Access Compliance Report

Public Rights-of-Way

(Curb Ramps)

Intersection ID: 2842	Main Street: BEAUVISTA_DR	Cross Street: ELM_COVE_LN	Location: NE
ADA ID: E8C26A0C9C05	Ramp Type: PerpDiag	Initial Pass/Fail: Fail	Overall Compliance: No
Severity Score: 10			
Codes/Mitigation Info/Possible Solution		Field Measurements/Component Compliance

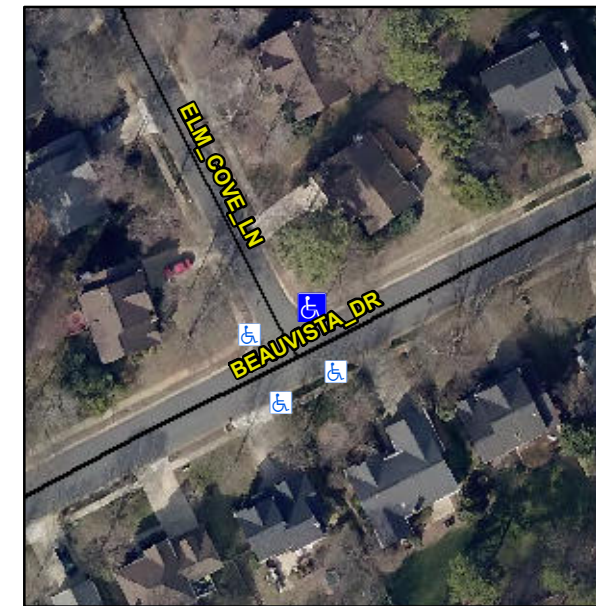
Not Found, R304.5.1, R304.5.3

Compliance	Description	Data	Compliance	Description	Data
N/A	Ramp Length (in)	47.0	Yes	Ramp Slope (%)	5.2
No	Ramp Width (in)	38.0	No	Ramp XSlope (%)	3.8
N/A	Flare Type LT	N/A	N/A	Flare Type RT	N/A
N/A	Flare Slope LT (%)	N/A	N/A	Flare Slope RT (%)	N/A
N/A	Flare Traversable LT?	N/A	N/A	Flare Traversable RT?	N/A
N/A	Landing Length (in)	N/A	N/A	DWS Provided?	N/A
N/A	Landing Width (in)	N/A	N/A	DWS Contrast?	N/A
N/A	Landing Slope (%)	N/A	N/A	DWS Length (in)	N/A
N/A	Landing X Slope (%)	N/A	N/A	DWS Full Width?	N/A
N/A	Landing Curb? (Y/N)	N/A	N/A	DWS Offset (in)	N/A
N/A	Shared Landing?	N/A			
N/A	Gutter Ponding?	N/A	N/A	Gutter Slope (%)	N/A
N/A	Gutter Lip Ht (in)	N/A	N/A	Gutter X Slope (%)	N/A
N/A	Painted X Walk1?	No	N/A	Painted X Walk2?	No
	X Walk 1 Direction	To W		X Walk 2 Direction	To S
N/A	X Walk 1 Width (in)	N/A	N/A	X Walk 2 Width (in)	N/A
	X Walk 1 Slope (%)	0.4		X Walk 2 Slope (%)	9.4
	X Walk 1 X Slope (%)	3.7		X Walk 2 X Slope (%)	1.7

Remove & Replace Curb Ramp With Two New Directional Ramps or Equivalent.
